PanoLock latch "spring-back" Issue

Lately we've encountered an issue with the PanoLock latch. When retracted, it is not springing back to latch the door. This issue happens mostly when paired with a grip handle. The problem lies with a weak spring inside the PanoLock and excessive drag within the PanoLock.

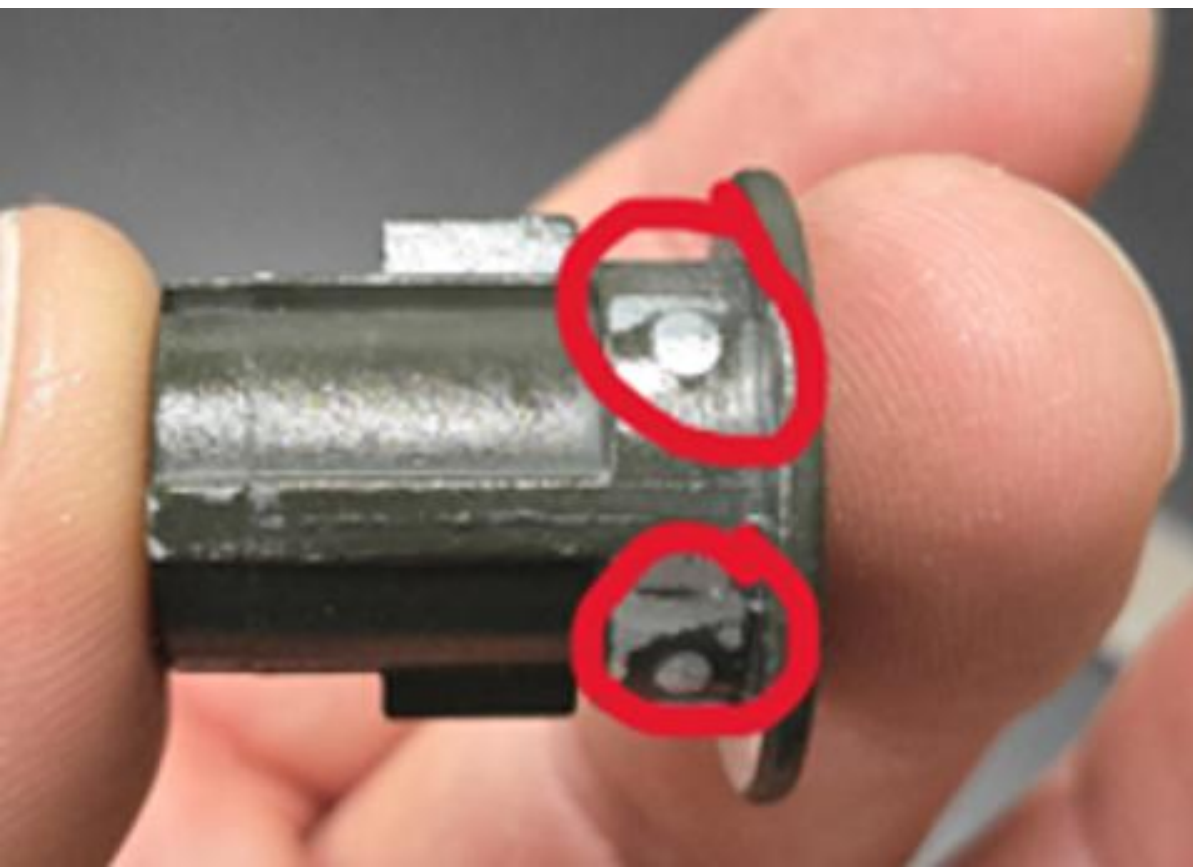
If you are using Emtek hardware, take the latch insert and file it down as shown in the photo. The Emtek insert just has one spot that needs filed.
